AMENDMENTS TO THE DRAWINGS

AMENDMENT UNDER 37 C.F.R. §1.111
U.S. APPLN. NO. 10/715,505

ATTY DKT Q78529

FIG. 4

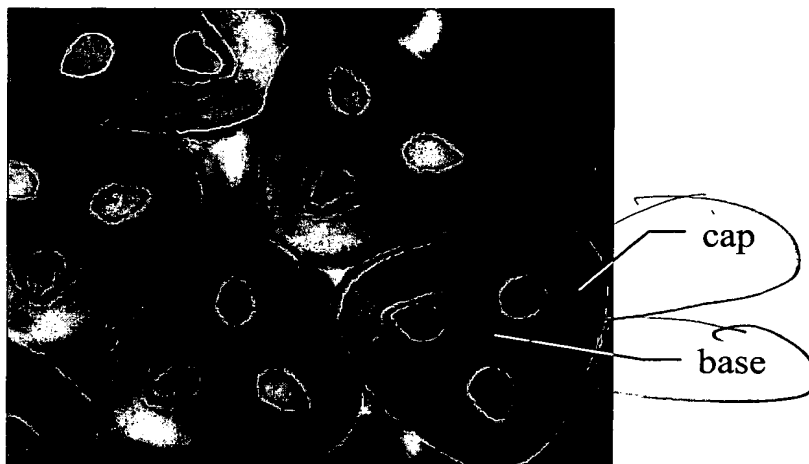
The drawings are objected to under 37 C.F.R. § 1.83(a). The Examiner states that the drawings must show every feature of the invention specified in the claims, including caps, base, porous hollow fiber with polygonal cross-section, and non-hollow fiber with multi lateral cross-section. The Examiner also states that Fig. 4 is unrecognizable and too dark.

Fig. 4 shows the non-hollow composite fibers with multilateral cross-section, as shown by a microscope having a power of 12.5x20 (as described in Example 1 at page 7). A representative cap and a base are now annotated on Fig. 4.

In response, Applicants submit concurrently herewith an annotated Drawing Sheet for Figs. 4-5, along with a Replacement Sheet for Figs. 4-5. Please note that Fig. 4 shows the non-hollow composite fibers with multilateral cross-section, as shown by a microscope having a

power of 12.5x20 (as described in Example 1 at page 7). A representative cap and a base are now annotated on Fig. 4. Similarly, Fig. 5 shows the porous hollow composite fibers with polygonal multilateral cross-section, as shown by a microscope having a power of 12.5x20 (as described in Example 2 at page 7). A representative cap and a base are now annotated on Fig. 5. No new matter is added.
